STAFF REPORT CONCERNING APPLICATION FOR A CERTIFICATE OF APPROPRIATENESS

Date: June 7, 2018

Application Number:2018-0605Property Location:608 Park AvenueArchitectural Style/Date/Architect or Builder:American Foursquare / 1910Property Owner:Stu HarrisonLandmark or District Designation:Chapin Park Local (Ordinance #9574-05) and National Historic DistrictRating:Contributing

DESCRIPTION OF PROPOSED PROJECT: Applicant seeks a Certificate of Appropriateness for the replacement of 10 windows (five double hung windows and five casement windows) with Quaker Classic Fit Series aluminum clad windows. None of the windows to be replaced directly face the street.

Figure 1 - 608 Park Avenue from the street, April 30, 2018

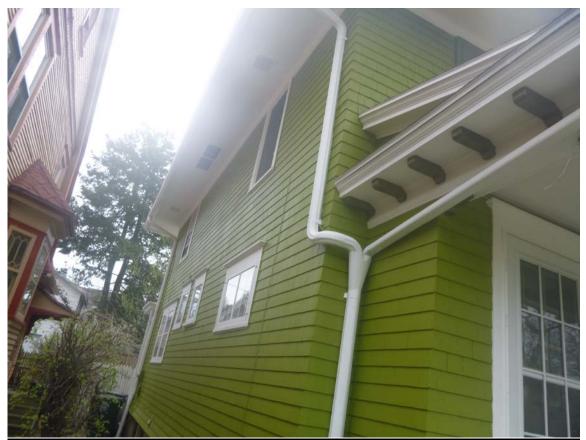
On April 30, 2018 I met with the owner of the property located at 608 Park. The owner applied to replace windows on the first level of the house. The windows have a nine over one double-hung and either nine or twelve-light fixed or casement style windows.

The double hung windows on the south side (right side when looking at front of house) are non-original replacement windows with false grids.

The front (west) window is a vinyl replacement three bay casement window that the owner would like to replace at a later date.

The rear (east) face has a three bay, nine light casement window unit. These are wood, but I do not believe to be original, as they have a veneer of wood finish that is peeling off.

The north side has a twelve-light original fixed window, two nine light original casement windows, and two original nine over one double hung windows with textured glass at the far end.

None of the windows appear to be deteriorated beyond repair. They all need work in order to be operable, although the secured-in-place exterior storms make that task difficult. The two nine light casements on the north face have had some remodeling done in between by way of a closed doorway and a removed staircase. Water damage from above has damaged some plaster and may have caused those windows to be out of square. The two textured windows toward the rear are painted and fastened shut. I believe the motivation behind the desire to change the windows is efficiency and ease of use. The distance between the property and the neighbors on both side make the sides of the house difficult to see from the street.

STAFF RECOMMENDATION: Staff would divide the components of this application into two categories: 1) the replacement of non-original windows with Quaker Classic Fit Series Windows, and 2) the replacement of original windows with Quaker Classic Fit Series windows.

The replacement of the non-original windows on the South and East side is received favorably by Staff, and is therefore recommended for approval.

The replacement of the original windows is considered less favorably, and staff would recommend that they be rehabilitated. In the event that the rehabilitation of the windows is not financially viable or physically possible, staff would recommend that those windows be replaced by Quaker Classic Fit Series units.
